Subject: RTG Revised Plan

Ottawa LRT Project – Project Agreement, dated February 12, 2013 ("Project Agreement")¹, between the City of Ottawa (the "City") and Rideau Transit Group Partnership ("RTG")

Confederation Line Major Issue Plan 20200424

Revised Inductor:

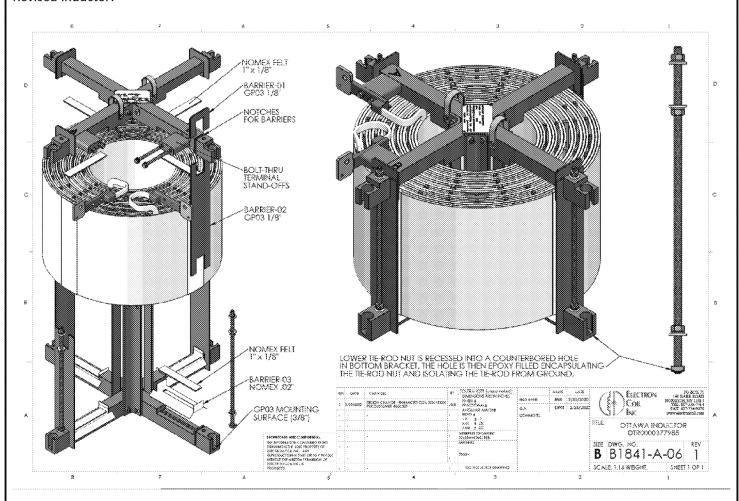
City Ref.	Remedy/Rectification Requir	rements	Responsible Entity & Lead
b)	-	y requires that RTG take the necessary steps (1-14) in the s its plan and schedule include measures to address the following	RTG/OLRTC RTM/ALSTOM
b)1.	Vehicle Power Systems – Power System	Due to an identified defect in the manufactured units appears to be partly mitigated with an insulating cover and modified cover the inductor units. The city requires that RTG provide full	ALSTOM
	Inductor Failures	technical details including drawings of the implemented changes to the Vehicle, schedule for replacement of the inductors, and signoff by the Engineer of Record on all completed and planned Vehicle Configuration changes.

Line Inductor Failure Analysis Report Doc # DED0000 Rev A shall be issued to the City as will Failure analysis report LINE INDUCTOR DTR0000377985 Doc # AYD0000561716

Revised Inductor:

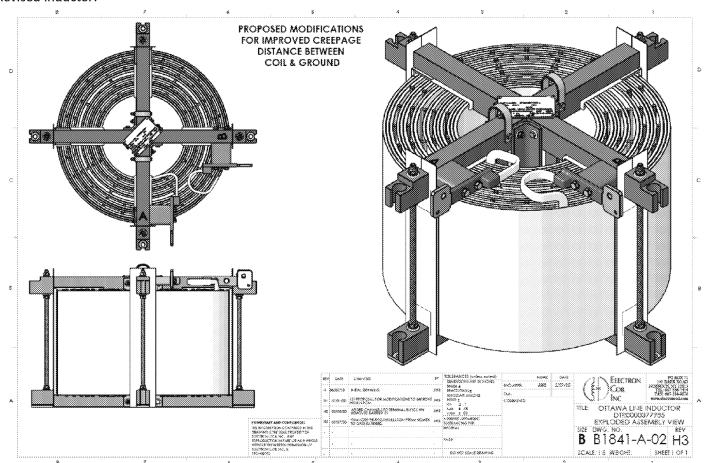
City Ref.	Remedy/Rectification Requir	rements	Responsible Entity & Lead
b)	-	y requires that RTG take the necessary steps (1-14) in the s its plan and schedule include measures to address the following	RTG/OLRTC RTM/ALSTOM
b)1.	Vehicle Power Systems – Power System	Due to an identified defect in the manufactured units appears to be partly mitigated with an insulating cover and modified cover the inductor units. The city requires that RTG provide full	ALSTOM
	Inductor Failures	technical details including drawings of the implemented changes to the Vehicle, schedule for replacement of the inductors, and signoff by the Engineer of Record on all completed and planned Vehicle Configuration changes.

Retrofit Schedule Constraints

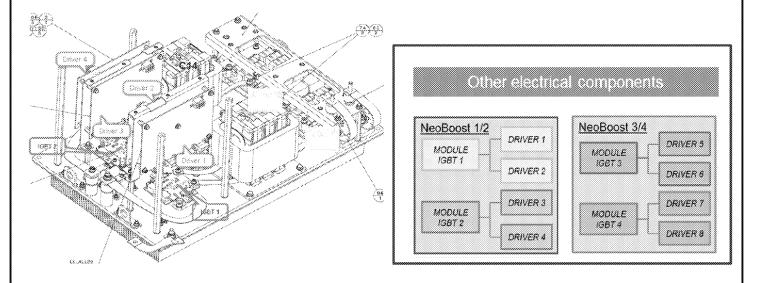
- a) With respect to the Line Contactor becoming stuck, Alstom identified two (2) separate and independent causes,
 - Line contactor mechanism has been improved to avoid mechanical issue. These improvements were presented and shared with the City end of February via (RFI-P) ALS 1111.

- it has been observed in service that when there is a flash over of the line inductor, the Line contactor tips become "kiss welded" leading to a true stuck closed condition. While the cause of this is still under investigation, the mitigation of line inductor flash over events eliminates this occurrence from happening.
